FINAL PLAT
 CEDAR RIDGE MOBILE HOME PARK
 WICHITA, SEDGWICK COUNTY, KANSAS

Re: S/D 97-16 - CEDAR RIDGE MOBILE HOME PARK (Final Plat)

Re: S/D 97-16 - CEDAR RIDGE MOBILE HOME PARK (Final Plat)

CASE NUMBER: S/D 97-16 - CEDAR RIDGE MOBILE HOME PARK

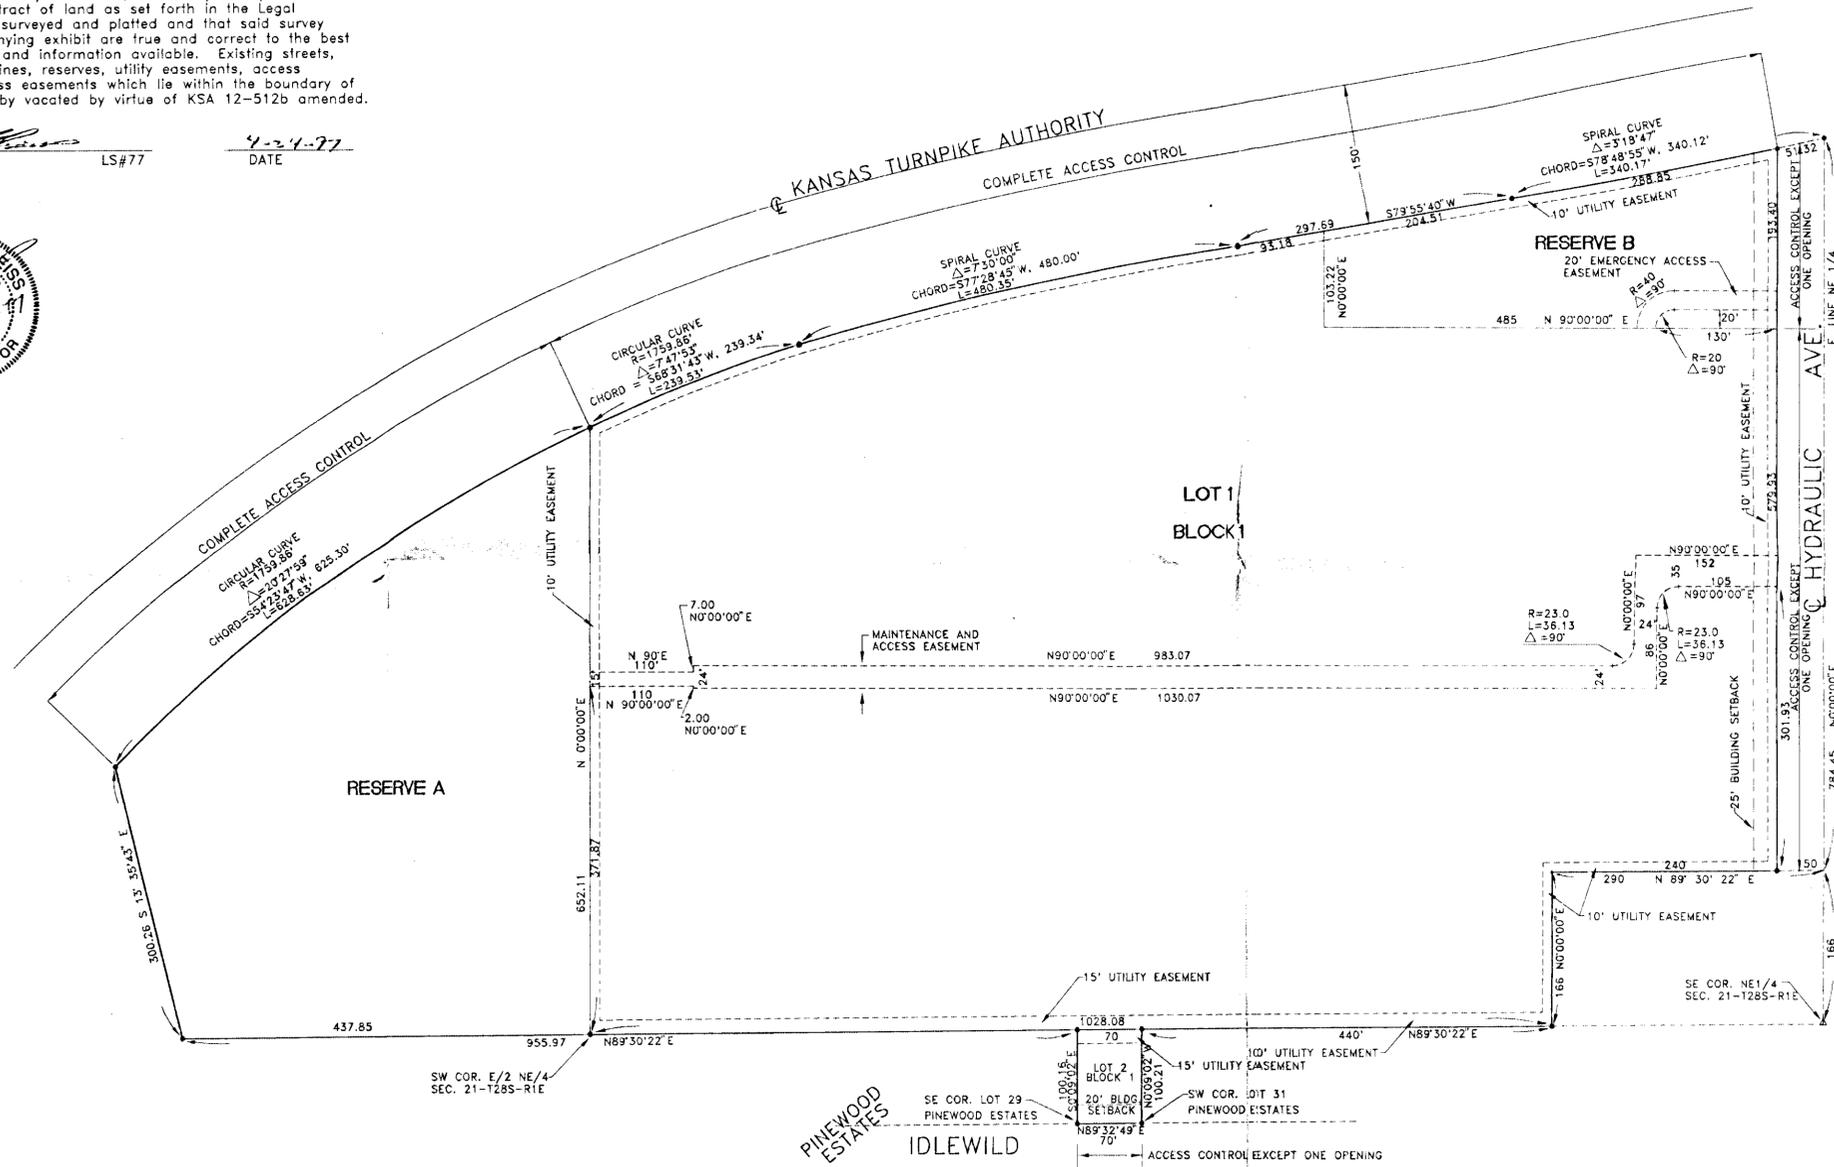
- D. On the final plat tracing, Lot 2, Block 1's boundary (lot lines) shall be shown at the same weight line as used for Lot 1. That is, Lot 2 shall be depicted in the same manner as the other portion(s) of the plat.

- E. On the final plat tracing, additional wording needs to be added to the platter's text in regard to the emergency access easement. Specifically, it needs to be indicated that this easement cannot be encumbered at any time, except that any improvements (driving surface, gates, etc.) will be to the standards determined by the City's Fire Department. The applicant is advised that an all weather surface must be provided and that any curbing shall be of the roll type.

- ~~F.~~ On the final plat tracing, the County Clerk's signature shall be corrected to read James Alford.
- ~~G.~~ The applicant shall install or guarantee the installation of all utilities and facilities which are applicable and described in Article 8 of the MAPC Subdivision Regulations. (Water service and fire hydrants required by Article 8 for fire protection shall be as per the direction and approval of the Chief of the Fire Department.)

- ~~H.~~ The applicant's engineer is advised that the Register of Deeds is requiring the name(s) of the notary public, who acknowledges the signatures on this plat, to be printed beneath the notary's signature.

- F. On the final plat tracing, Lot 2, Block 1's boundary (lot lines) shall be shown at the same weight line as used for Lot 1. That is, Lot 2 shall be depicted in the same manner as the other portion(s) of the plat.

- G. On the final plat tracing, additional wording needs to be added to the platter's text in regard to the emergency access easement. Specifically, it needs to be indicated that this

easement cannot be encumbered at any time, except that any improvements (driving surface, gates, etc.) will be to the standards determined by the City's Fire Department.

- H. On the final plat tracing, the County Clerk's signature shall be corrected to read James Alford.
- I. The applicant shall install or guarantee the installation of all utilities and facilities which are applicable and described in Article 8 of the MAPC Subdivision Regulations. (Water service and fire hydrants required by Article 8 for fire protection shall be as per the direction and approval of the Chief of the Fire Department.)

- J. The applicant's engineer is advised that the Register of Deeds is requiring the name(s) of the notary public, who acknowledges the signatures on this plat, to be printed beneath the notary's signature.

- N. The representatives from City Engineering should be prepared to comment on the status of the applicant's drainage plan. Engineering also needs to indicate if the minimum building elevation is correct.
